ASSY TOP

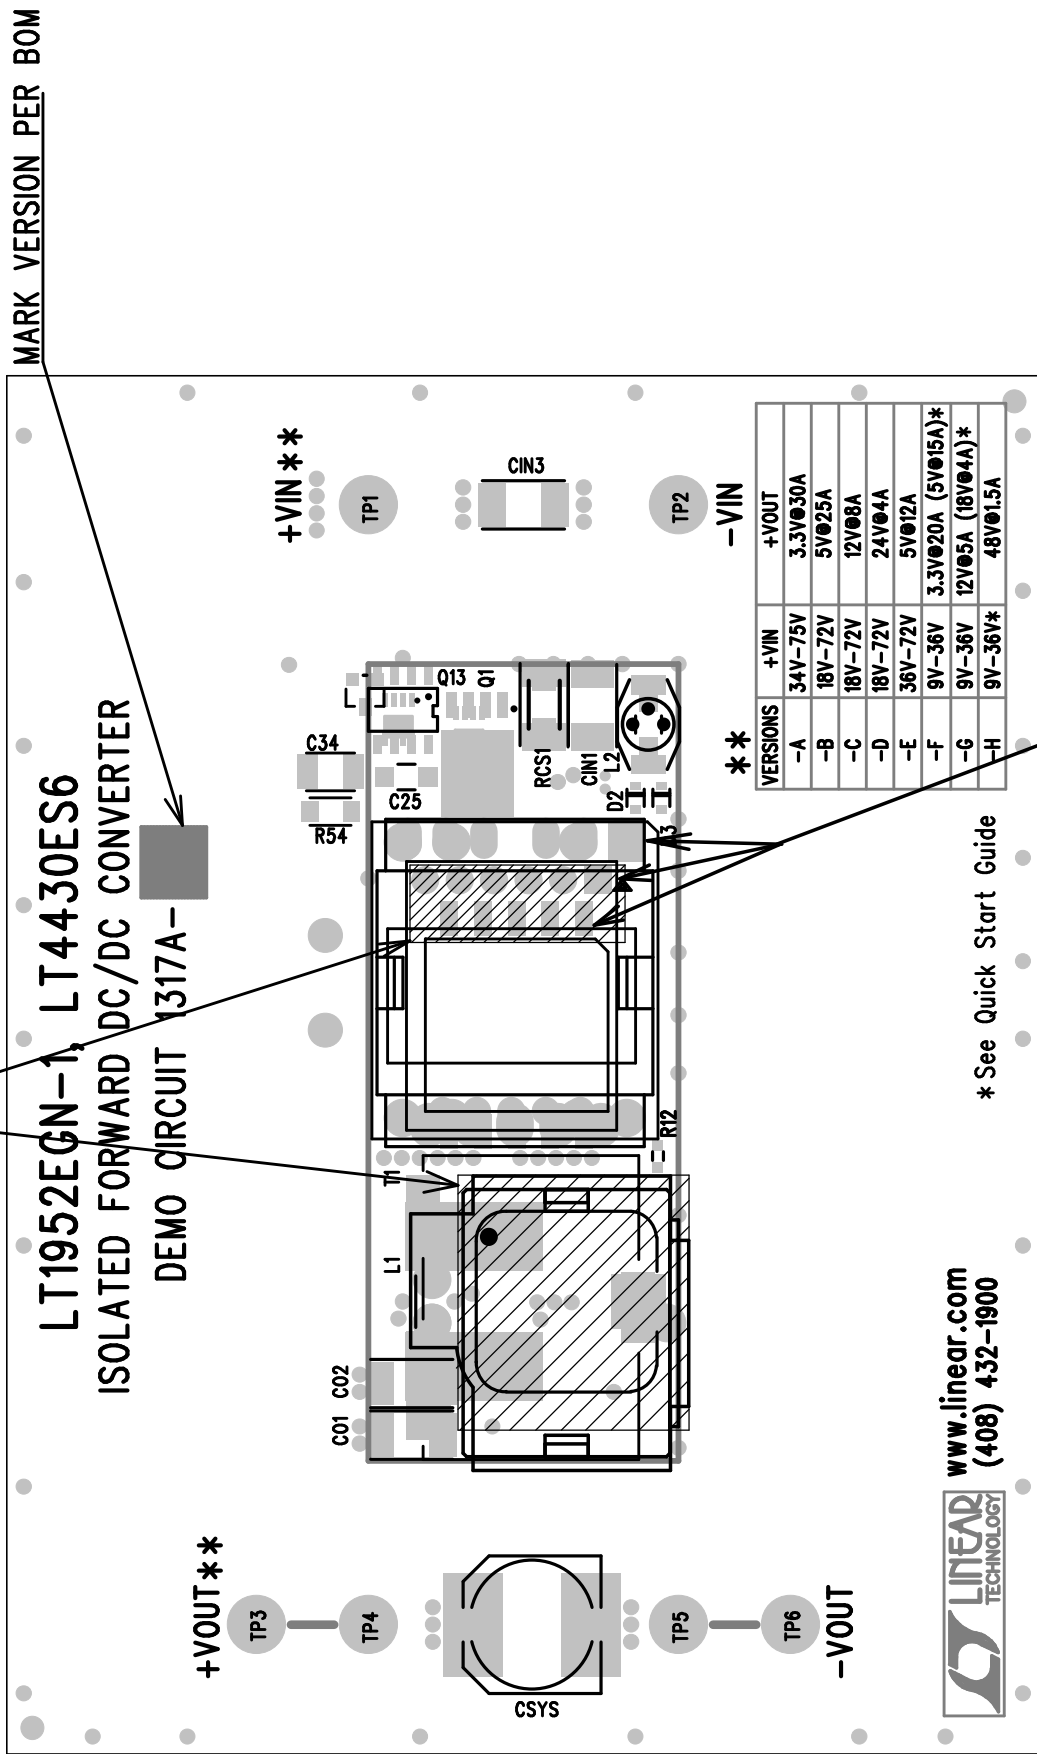
Because of multiple footprint in this design.  
Place a piece of kapton tape on board as shown  
to insulate T1 and L1 from open copper. No solder  
under kapton tape area (tape off the stencil opening  
for not used pads under T1 and L1).
